From: Mark Artinian, Building Inspector/Plan Reviewer
To: Kristen Kapelanski, Planning Department
Date: June 28, 2019
Re: Detroit Chinese Alliance Church Parking Lot – Site Plan Review #1
1591 W Auburn Rd.
Sidwell: 15-33-128-010
City File: 19-029

From: Jason Boughton, AC, Engineering Utilities Specialist
To: Kristen Kapelanski, AICP, Planning Manager
Date: September 9, 2019
Re: Detroit Chinese Alliance Church, City File #19-029, Section 33
Site Plan Review #3

Parking Lot Expansion Plan
DETROIT CHINESE ALLIANCE CHURCH NORTH
CITY OF ROCHESTER HILLS, GARLAND COUNTY, MICHIGAN

From: Kristen Kapelanski, AICP
Date: 9/13/2019
Re: **Detroit Chinese Alliance Church – Parking Lot
Site Plan - Planning Review #3**

SCALE 1" = 30'
SHEET 3 OF 8
KE 2018.133

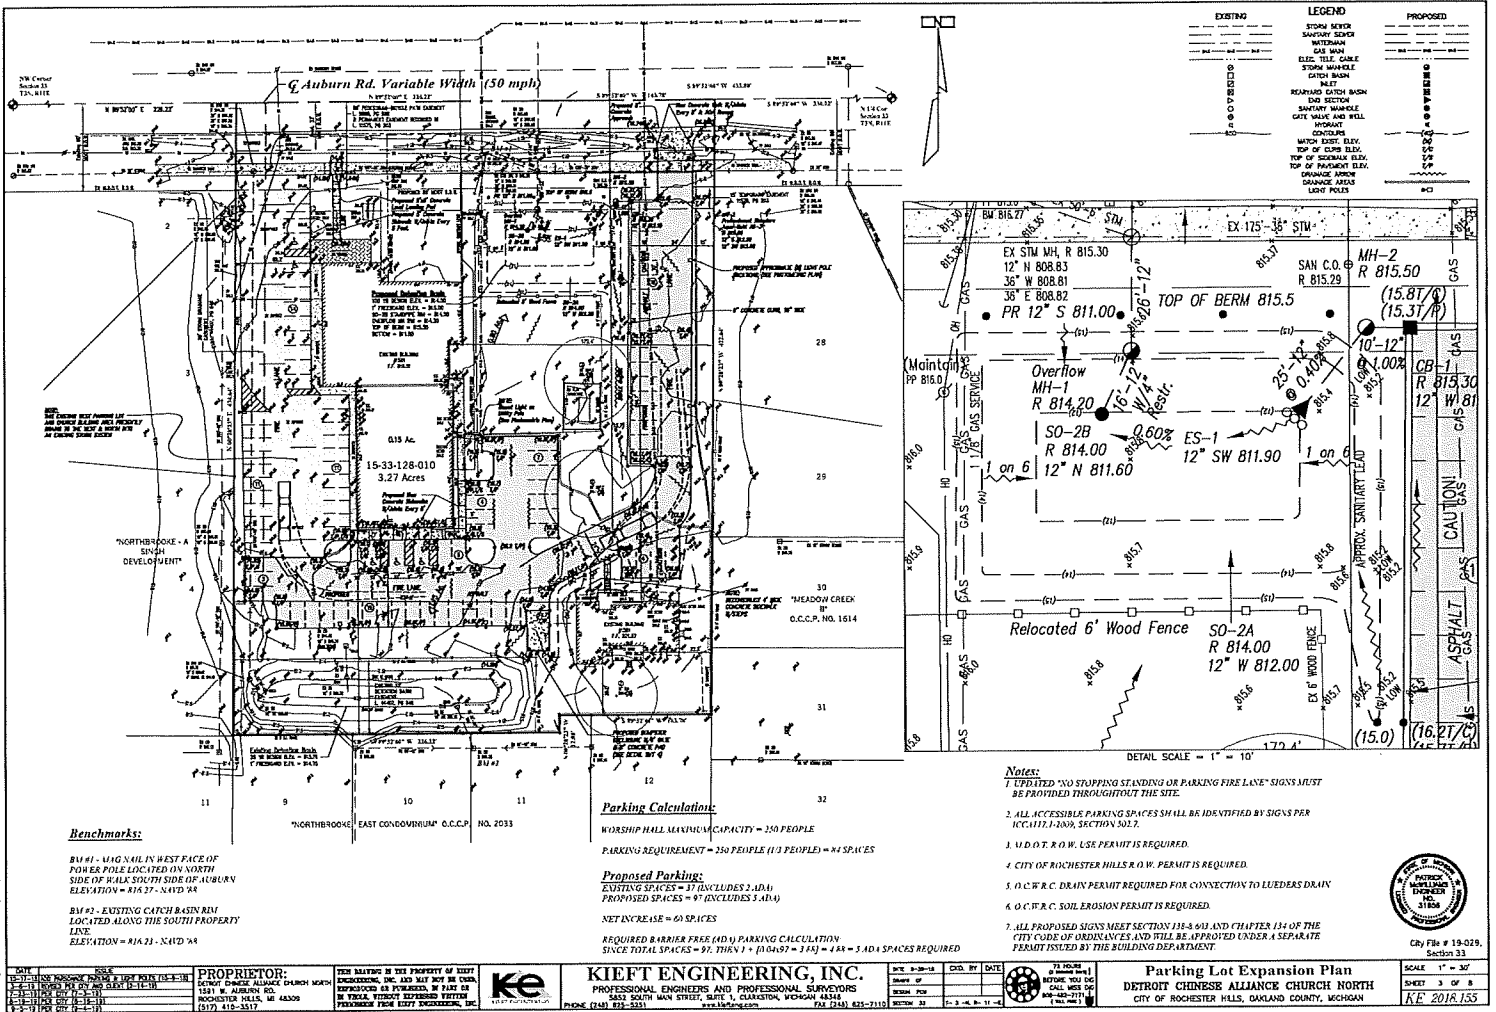
1. When establishing grade elevations around the buildings please consider that landscape areas adjacent to buildings shall pitch away from the foundation at a 5-percent slope for a minimum of 10 feet from the foundations. Impervious surfaces within 10-feet of the building should be sloped at a minimum 2-percent slope. Verify compliance at the new sidewalks adjacent to the new parking lots at the south and east sides of the building.

2. Three new proposed accessible parking spaces have been proposed on the south side of the building. Verify that the existing southern entrance(s) meet all accessibility requirements.
3. The sidewalk adjacent to the accessible parking spaces shall be a minimum of 7' wide to accommodate 2-way accessibility.
